PREVOST

WARRANTY BULLETIN

WB16-02H

DATE :	MAY 2016	SECTION :	06 - Electrical
EXPIRATION:	MAY 2018		
SUBJECT :	CHARGING SYSTEM IMPROVEMENT

FIGURE 9

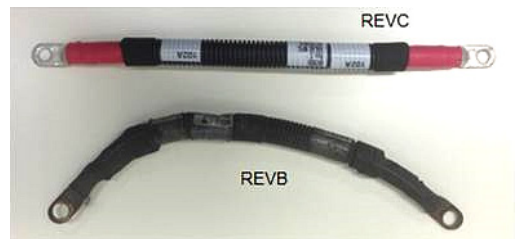
Rev.B diameter of the through hole is too large, reducing contact surface with the stud and the nut thus reducing electrical conductivity between the lug and the alternator stud (FIGURE 9).

7. Reinstall the jumper cable **#067835 revision C** included in kit #7770335 (FIGURE 7, FIGURE 8).

FIGURE 10

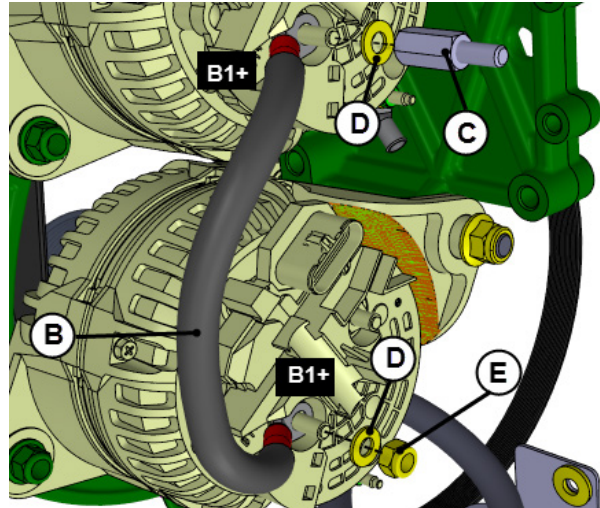
-
8. Reinstall appropriate jumper cable **B** (i.e. rev.C) with appropriate stud adapter. Refer to **FIGURE 10**.

Note: M8 nut "E" formerly #5001787 is canceled. Use nut #5001983 instead.

- B : JUMPER CABLE #067835 revision C**
C : STUD ADAPTER #060297 torque: 10 lbf-ft
D: FLAT WASHER #5001341
E: NUT M8 #5001983 torque: 10 lbf-ft

FIGURE 11

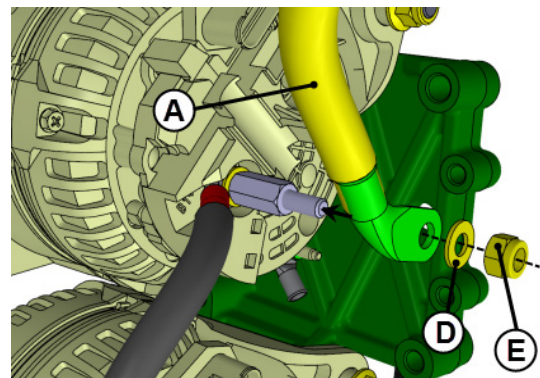
-
9. Reinstall power cable **A**. To do so, connect power cable **A** to the upper alternator **B1+** stud terminal. Refer to **FIGURE 11**.

Note: M8 nut "E" formerly #5001787 is canceled. Use nut #5001983 instead.

- A : POWER CABLE**
D: FLAT WASHER #5001341
E: NUT M8 #5001983 torque: 10 lbf-ft

FIGURE 13

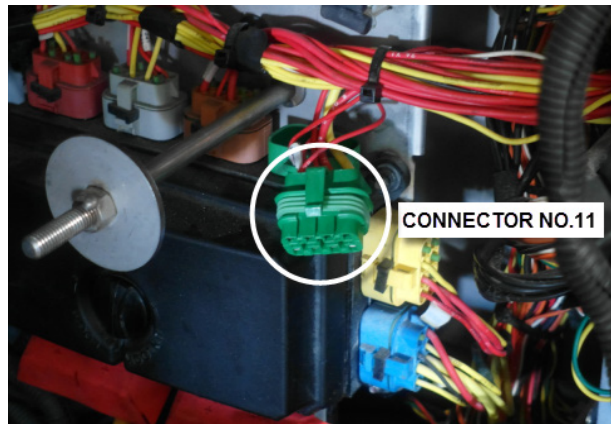
3. Using an extractor tool or a small flat blade screwdriver, remove wire 24VDALT from cavity H of connector no.11 (FIGURE 13 to FIGURE 16).

FIGURE 18 : WIRING DIAGRAM PAGE 5.1

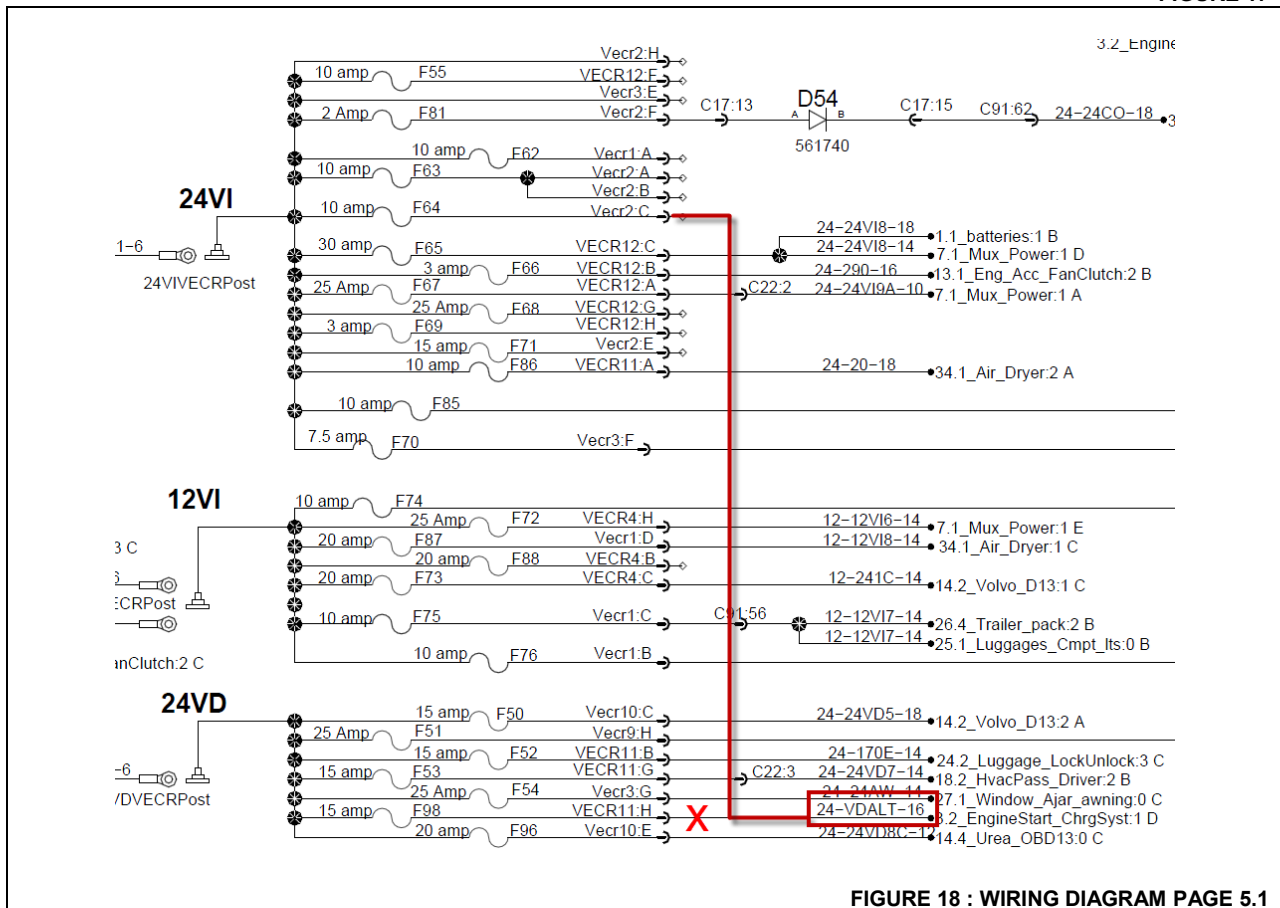
4. Relocate wire 24VDALT to cavity **C** of connector no.2 (red) on the harness.

Cavity **C** of connector no.2 should be available. This branch of the circuit will be protected by 10A fuse F64 (see FIGURE 18 below).

Should cavity C not be available, refer to your vehicle wiring diagram page 5.1 to select another free cavity protected by a 10A or 15A fuse (see FIGURE 18 for reference).
